## Evaluation of 2019 Ar-41 Measurements and Analysis

Several non-conformities (NCs) between the 2019 Ar-41 measurement and analysis and those from previous years have been identified. These are described below with corresponding Corrective Actions (CAs). Based on new analysis of 2019, 2014, 2009 and 2008 Ar-41 data and review of the Ar-41 release reports dating back to 2005, several Opportunities for Improvement (OFIs) have also been identified that could improve the consistency and reliability of the measurement and analysis procedures going forward.

Fig. 2. Background and sample spectra as used in 2019 analysis. Spectra are shifted vertically.

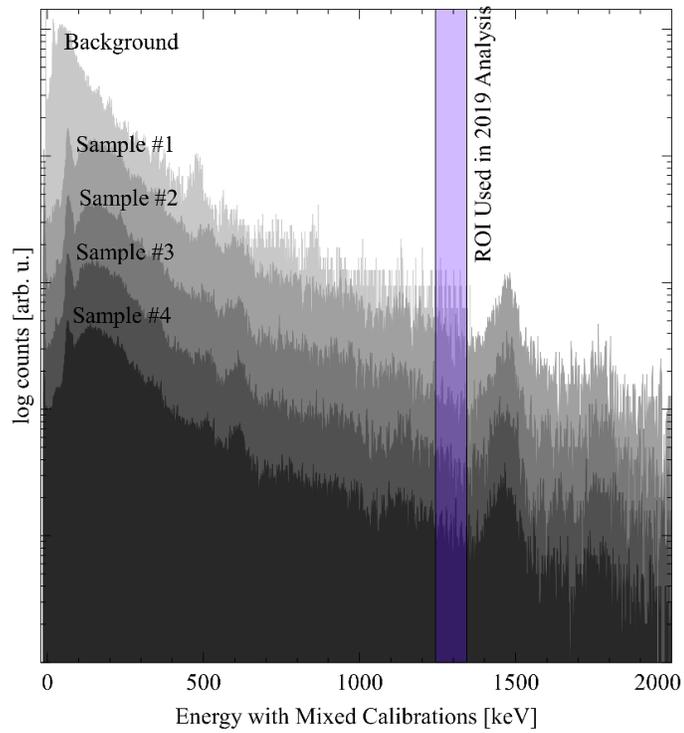
Summary: Upon inspection of the raw spectra files, it became apparent that two different energy calibrations were used in the analysis. One calibration was applied to both the Na-22 standard and background spectrum while the other was applied to the four air samples. The calibration of the Na-22 spectrum was deemed to be correct as two photopeaks, centered at 1274 keV and 511 keV, coincide with the Na-22 characteristic gamma and annihilation photon, respectively. The energy calibration applied to the four air sample spectra were also determined to be correct through comparison of spectra collected during the 2014 Ar-41 analysis. When the same calibration used with the sample spectra was applied to the background spectrum, the locations of the four aforementioned background peaks and continuum shape overlapped (see Fig. 1). However, as mentioned above, the energy calibration used for the Na-22 spectrum was applied to the background spectrum. The situation is represented in Fig. 2.

A shaded rectangle indicates the region of interest (ROI) used to quantify the Ar-41 activity. No photopeak can be visually identified in any of the spectra. Therefore, the ROI gross counts in each of the sample spectra primarily reflect the continuum background. If a photopeak was present, the chosen ROI would be slightly narrower than the FWHM of the photopeak, which would result in underestimation of photopeak area. Use of 50 channels is called for in the counting procedure. However, in the years when that procedure was developed, the detector and multi-channel analyzer (MCA) was configured to have an approximately 10 keV/ch bin width. In 2014 and 2019, 2 keV/ch were used.

In the quantification procedure, the gross background counts were subtracted from the gross sample counts. Due to the use of the incorrect energy calibration in the background spectrum, the gross background counts, having been measured at a higher energy (around 4000 keV), were significantly lower than the continuum background of the sample spectra in the Ar-41 region. Thus, the quantity reported as the net Ar-41 counts was essentially a difference in gross counts within two different energy ranges of the same background, a physically meaningless quantity. This explains why the reported Ar-41 concentrations at each sampling location were all similar in value ( $3.11 \times 10^{-6}$  -  $3.27 \times 10^{-6}$   $\mu\text{Ci/mL}$ ) and an order of magnitude larger than expected based on the SAR and results from previous years.

- CA 2.1. SOP 654 shall be revised to establish an ROI selection procedure based on detector type, HV, gain and MCA settings.
- CA 2.2. SOP 654 shall be revised to establish detailed procedures that ensure a common and correct energy calibration is applied to the spectra. It will also provide additional guidelines for selecting HV and gain settings.

Fig. 3. Comparison of spectra from Na-22 standard and background. Note that the counting times were the same (1800 s).

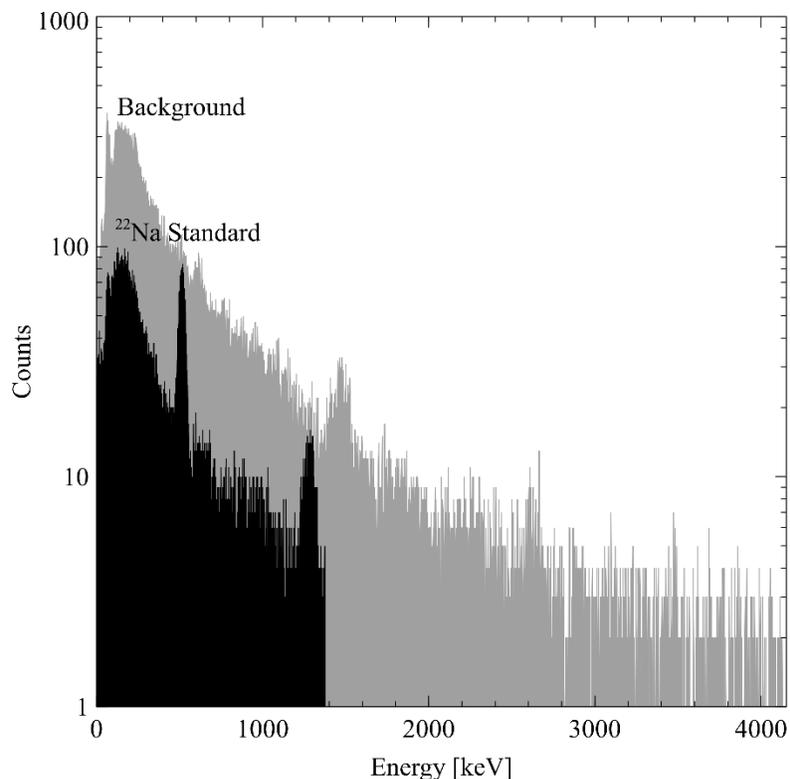
As the Na-22 spectrum had a different energy calibration, it is possible that the high voltage (HV) or gain settings were changed for that acquisition. Indeed, the continuum background in the Na-22 spectrum was significantly lower than the background spectrum (Fig. 3). It is therefore doubtful that a simple method of gross background count subtraction would result in an accurate efficiency determination.
